NUCLEAR REGULATORY COMMISSION

Title: Advisory Committee on Reactor Safeguards
Open Session Meeting

Date: Thursday, May 7, 2015

***Maximum Extended Load Line Limit
Analysis Plus***

Margin Analysis

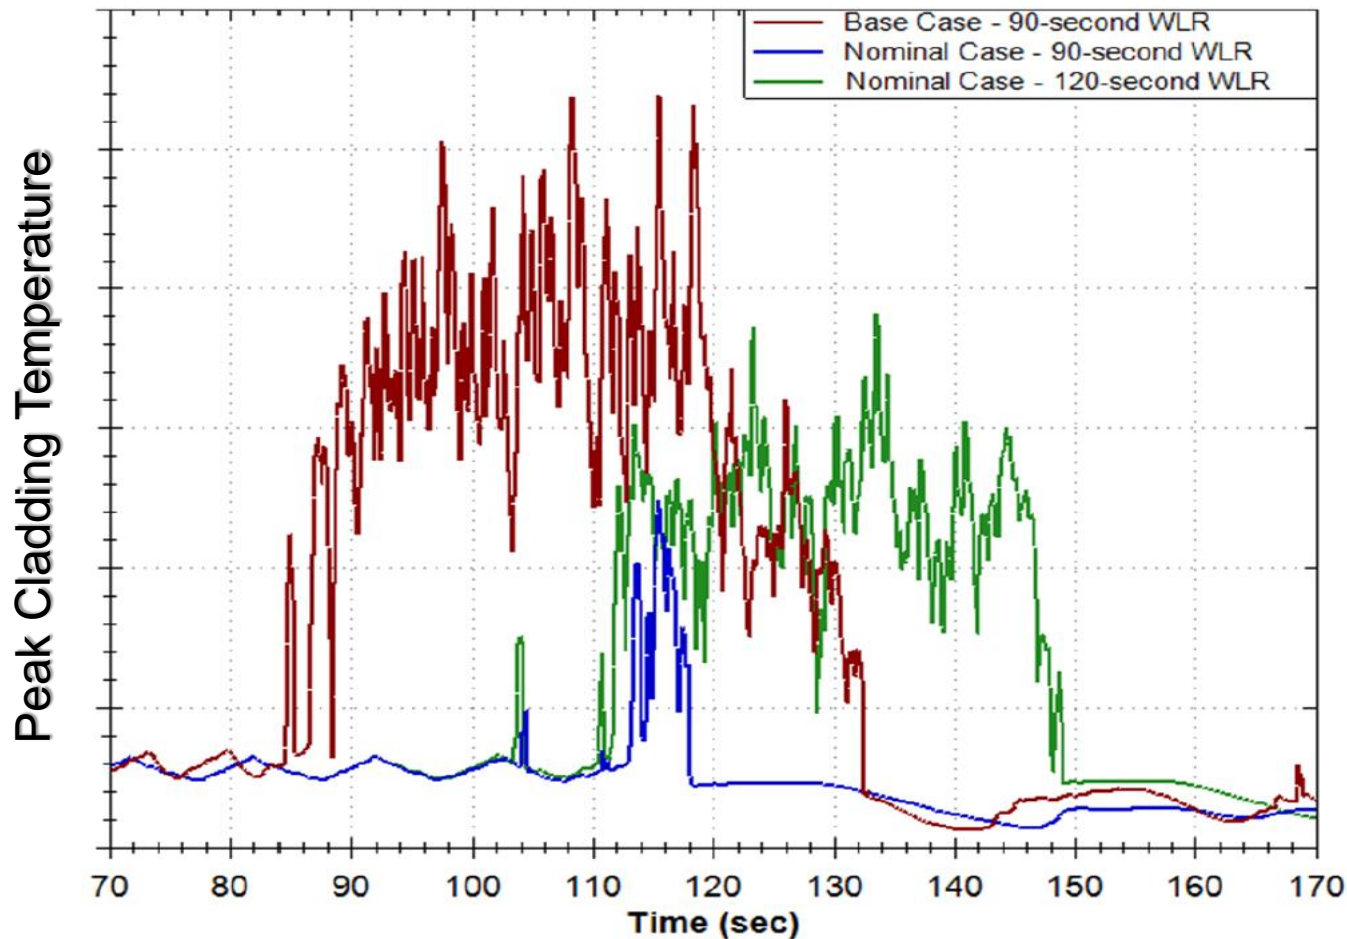
16 The green and the blue is where we use the
17 nominal assumptions, and with the blue we still assume
18 the 90-second operator response time, and you can see
19 that we barely saw any oscillations. And with the
20 green we assumed 120-second operator response time,
21 and there were some oscillations but it was bounded by
22 the license basis case.
